### **ITEM FOR ENVIRONMENTAL COMMISSION AGENDA**

**NAME & NUMBER OF PROJECT:** Water Oak Apartments  
SP-2019-0109C

**REQUEST:** Variance request is as follows:  
1. Request to vary from LDC 25-8-341 to allow cut in excess of 4 feet on slopes exceeding 15 percent.

Development Services Department  
Staff Recommendations Concerning Required Findings

**EXHIBIT 4**  
**EXISTING TOPOGRAPHIC AND TREE**  
**MAP**

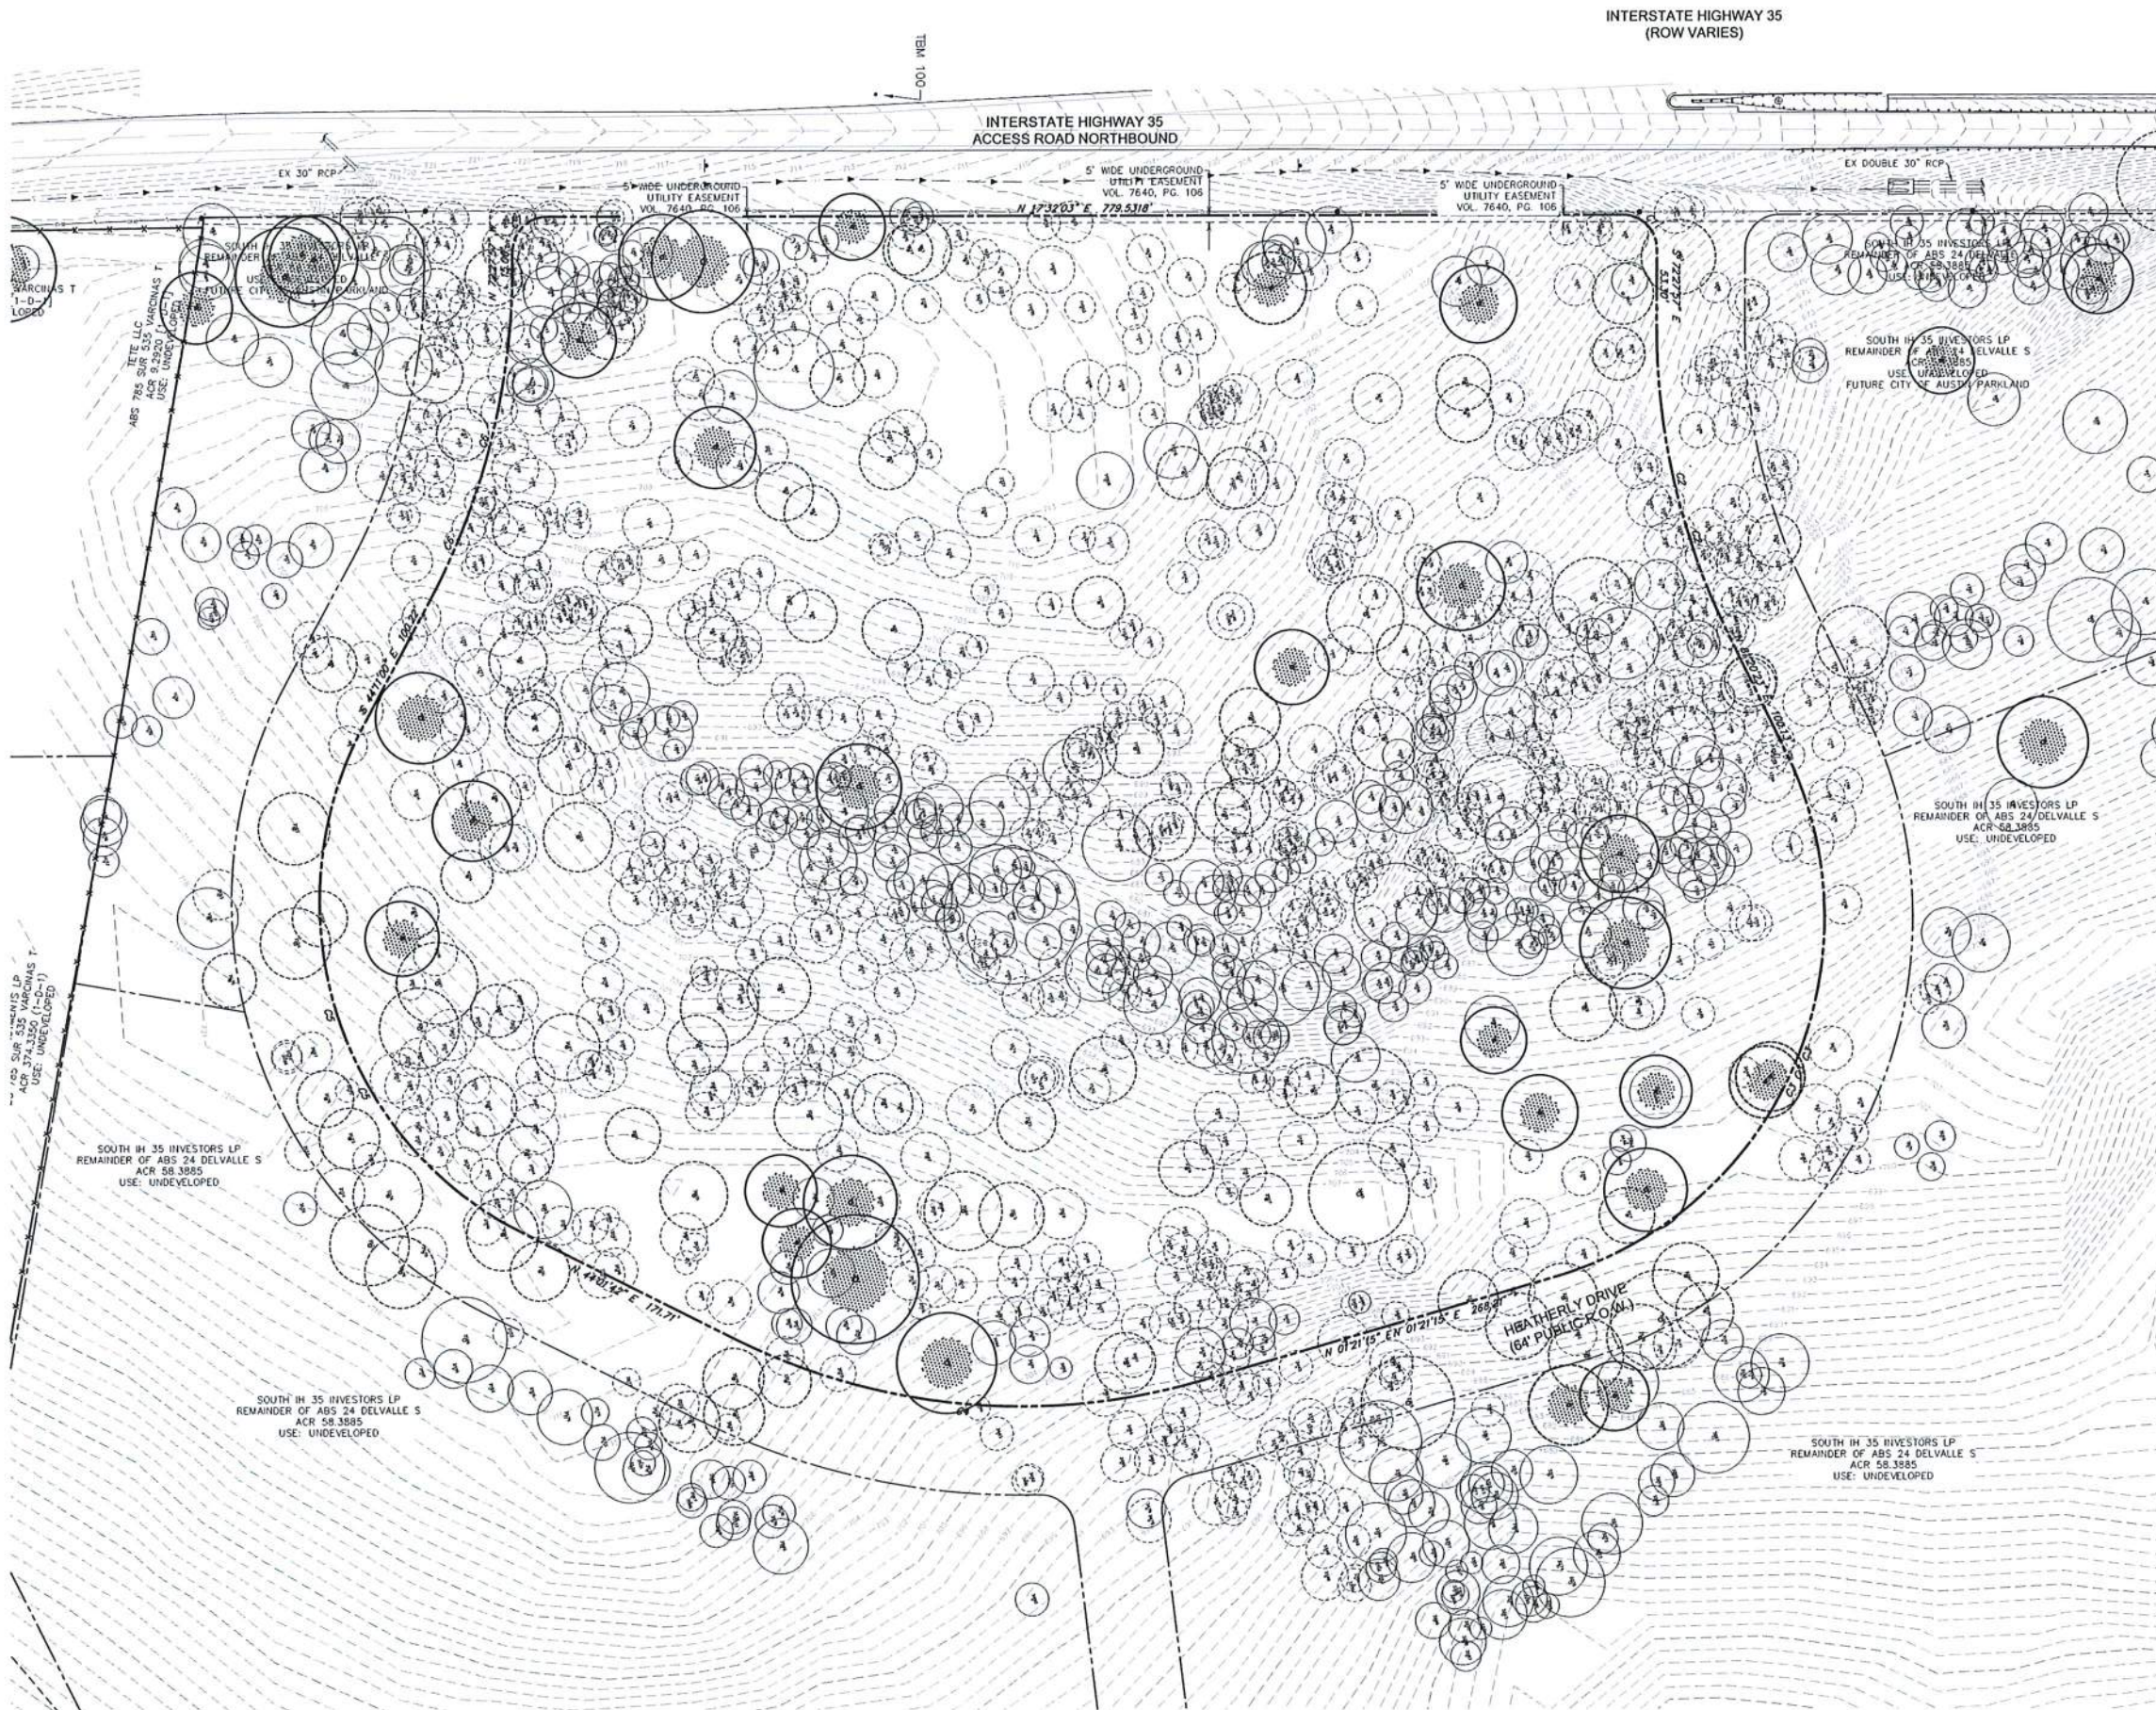
Yes The site slopes toward the middle, from east and west, toward an unclassified creek (drainage area less than 64 acres) that bisects the lot (see Applicant Exhibit 4 for topography). With a gross site area of 21.4 acres, 1.6 acres have slopes between 15 and 25 percent, 0.5 acres have slopes from 25 to 35 percent, and 0.04 acres have slopes over 35 percent. The steepest slopes are at the north, downstream end of the creek. This is also the best location for the detention pond, since it is the lowest point of the site.
